RE: SHIPLEY DO-NUTS, PRINCESS JEANNE PARK (J21-D19B). ENGINEER'S CERTIFICATION FOR CERTIFICATE OF OCCUPANCY APPROVAL. ENGINEER'S STAMP DATED NOVEMBER 16, 1999. G&D Plan APRIL 22, 1999.

RE: SHIPLEY DO-NUTS, PRINCESS JEANNE PARK (J21-D19B). GRADING AND DRAINAGE PLAN, and DRAINAGE REPORT FOR BUILDING PERMIT, GRADING PERMIT, AND SO#19 PERMIT APPROVALS. ENGINEER'S STAMP DATED APRIL 22, 1999.

RE: Drainage Report for Shipley Do-Nuts, Tract D2, Block 7, Princes Jeanne Park

Site Plan submittal for building permit approval for Shipley Donuts, 1450 Eubank Blvd. N.E. Princess Jeanne Park Subdivision, Tract D2, Bolck 7, Architect's Stamp dated 4/19/99.

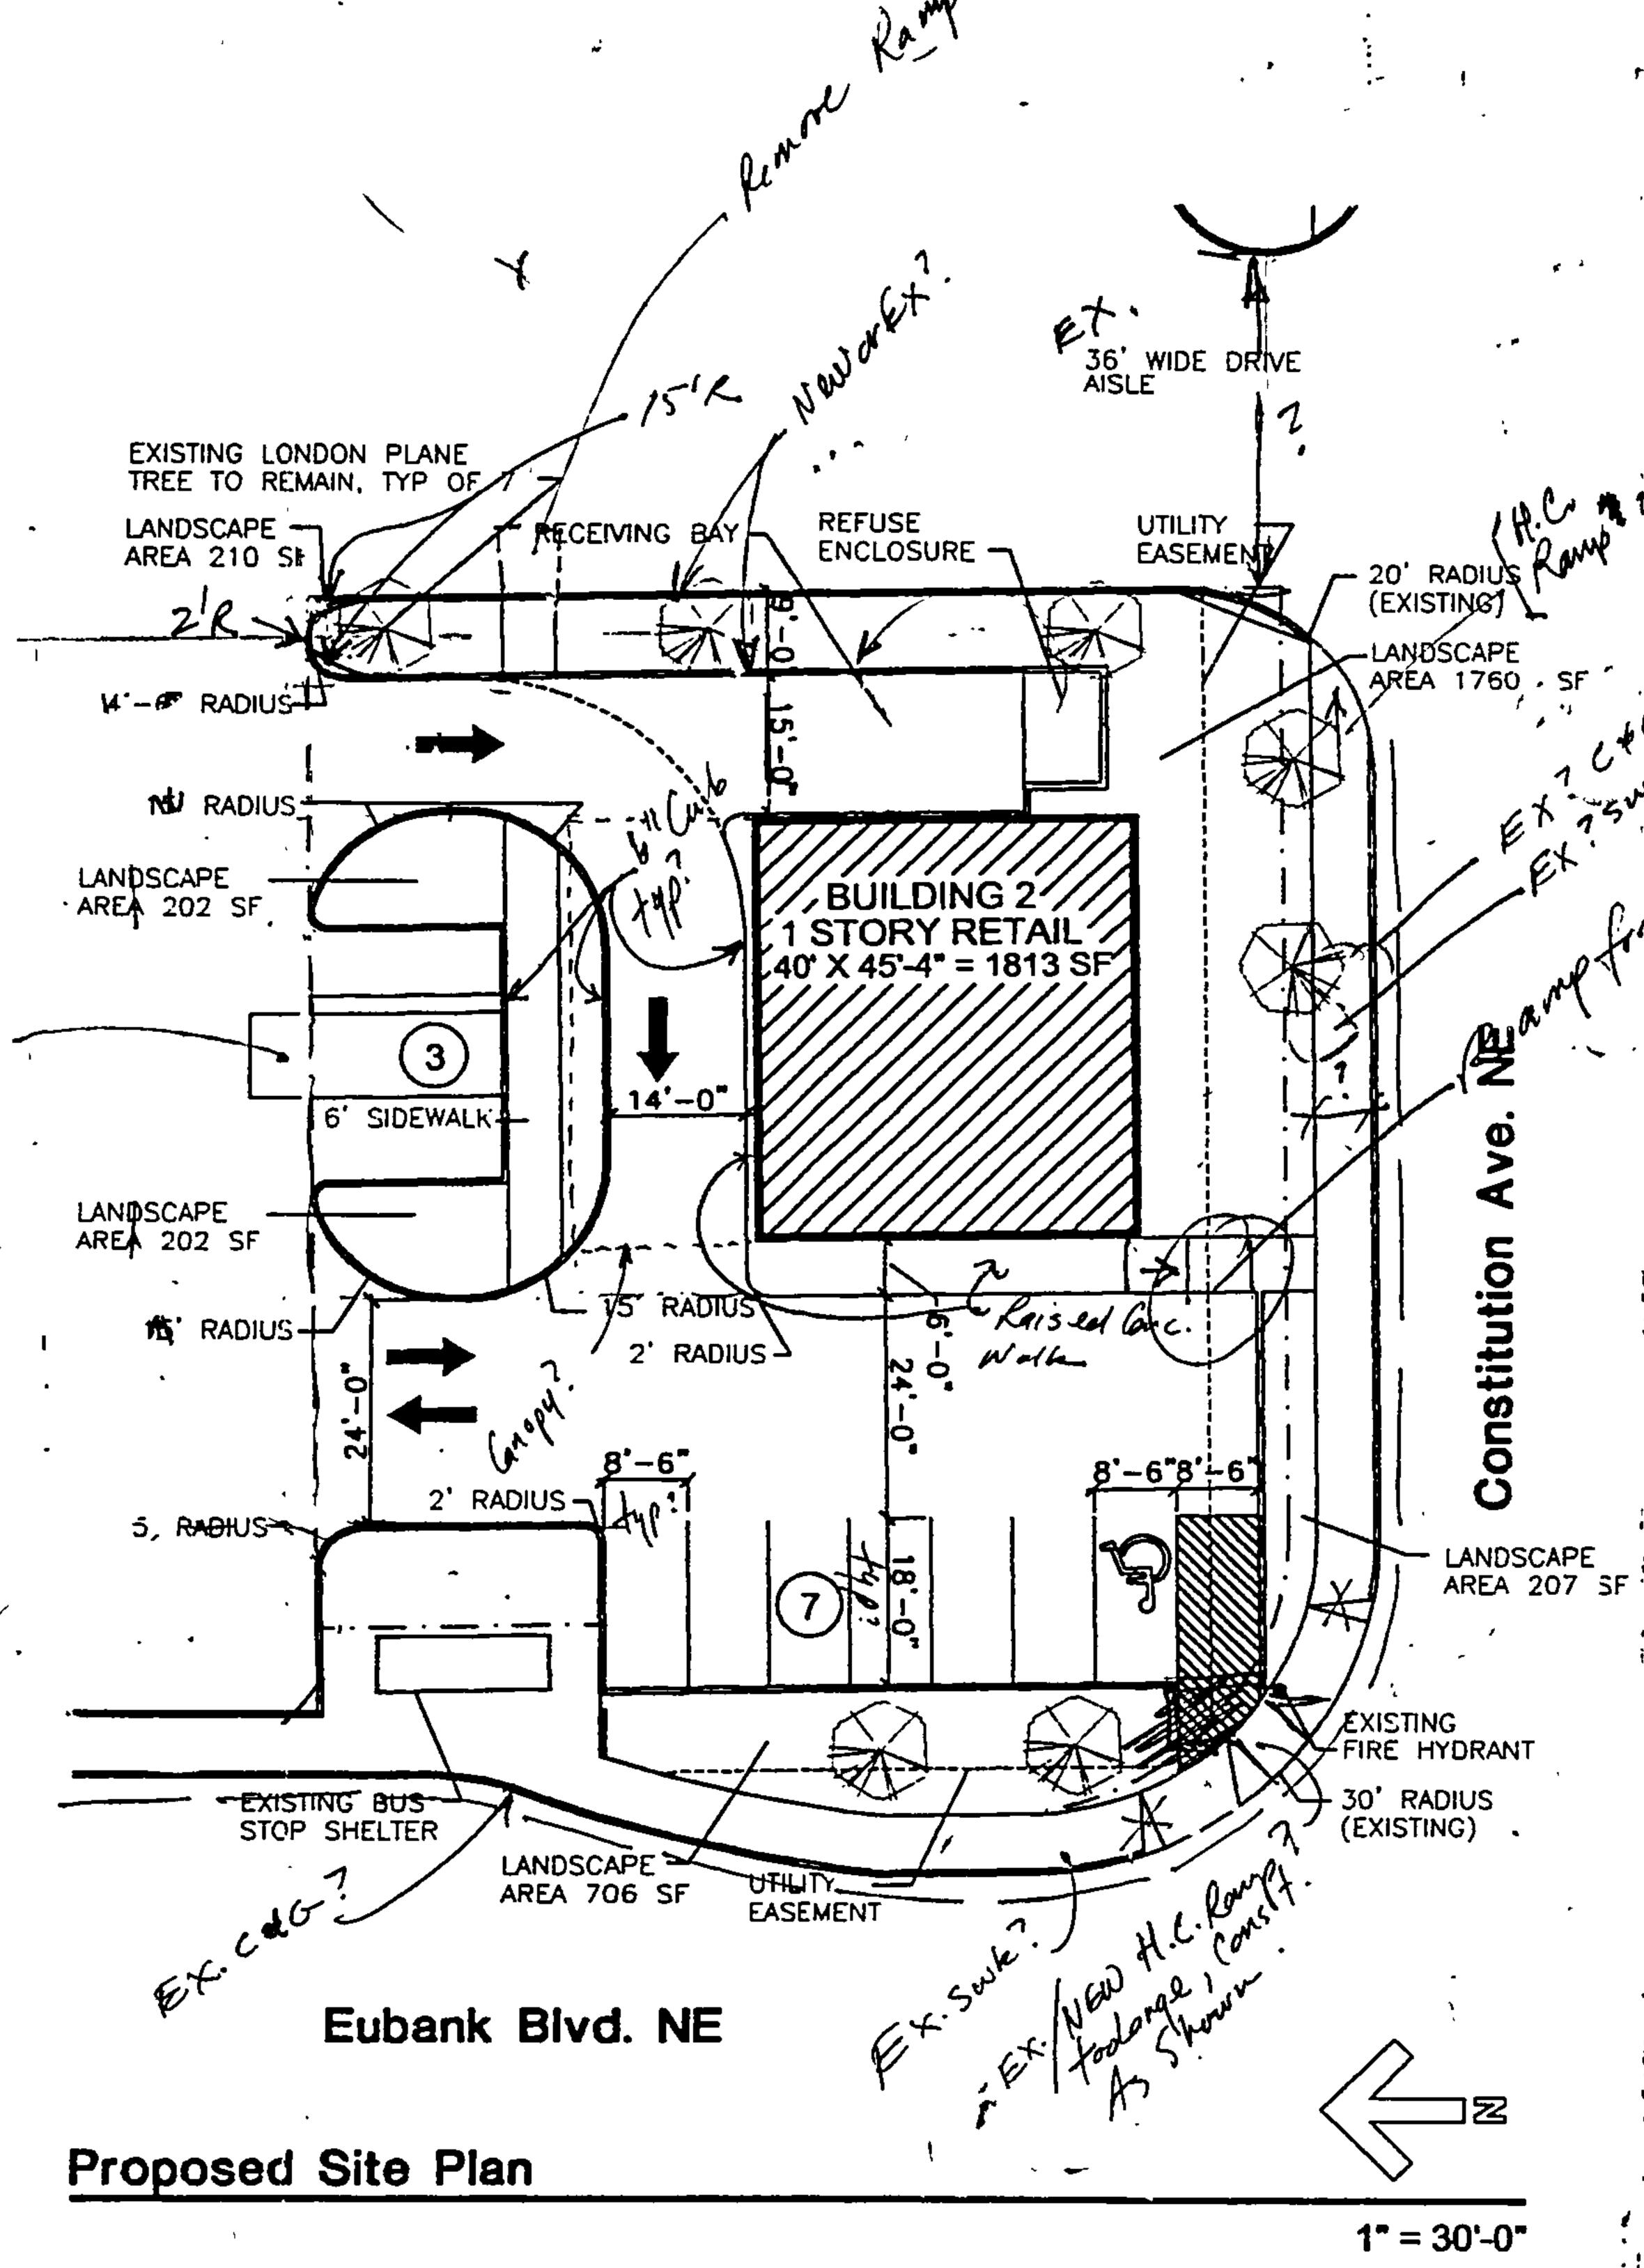
The above referenced plan requires modification to the Site Plan prior to Building Permit release as follows:

- Note on Site Plan: ALL ASPHALT AND CONCRETE CONSTRUCTION MUST BE 100% COMPLETE BEFORE INITIAL INSPECTION, FOR TEMPORARY C.O., WILL BE SCHEDULED.
- Comments have been noted and original submittal is red-lined. Please return marked up plan with second submittal.

- For future reference place on Site Plan: vicinity map & Zone Atlas number. State how site is zoned. Show full width of all streets.
- Landscaped island on east side, Show new and/or existing accurately?

- New and existing elements noted on the <u>Site Plan</u> must be shown, labelled, and dimensioned correctly and accurately, this includes street sidewalks and curb & gutter, all drive aisles, etc.__Need to see clear differentiation between new construction and existing on Site Plan.

- Show building "footprint" including canopy over drive-thru.
- · Need to see that all existing obstacles in City right-of-way, in existing sidewalks, have been picked up.

- In General Note, state that all existing street sidewalk and C&G in disrepair affecting safe pedestrian and/or vehicle travel will be removed and replaced.

- Linework on Drainage Plan must match Site Plan exactly.
- Label curbing at all individual locations or show double-lined curb line type and label curb type and material. Label "typical" or refer to detail used "... typical".

- Label R/W and property lines.
- · Sidewalk must be in City property. If applicable, R/W line may need to be adjusted on plat to reflect this.
- Label new and existing asphalt surface, show clear limits of construction.__Label thickness of asphalt parking surface per city std. or
 refer to a detail which illustrates the proposed method of paving and states it's equivalency to standard asphalt surfacing.

- Signs needed at entrance to one-way drive aisle.__Label to paint arrows.
- Refuse Enclosure on Site Plan-- will need to see approval from Solid Waste.

- Only one SitePlan is needed per Permit submittal. Any excess SitePlans will need to match the Approved Site Plan exactly.
- Clearly show point of transition from one type of surface to the other(ramps, concrete/asphalt, etc.) on Site Plan or on detail.__Show, label and dimension all new and existing HC.ramps or reference detail. and show sloping of ramps using arrows.__Show and label H.C. signs.

- Minim. 5'wide sidewalk needed at stalls along front of building, raised 6"above parking surface. Show, label and dimension.
- Pedestrian access from City sidewalk through proposed HC. access aisle near corner HC.ramp cannot be allowed, continue concrete curbing. Seems to be provided further east.

Please provide revised Site Plan reflecting above requirements and copy of replat for my files. Also verification from stated sections is needed, including Zoning regarding Rio Grande Cooridor. If you have questions please come by so I can clarify as necessary.
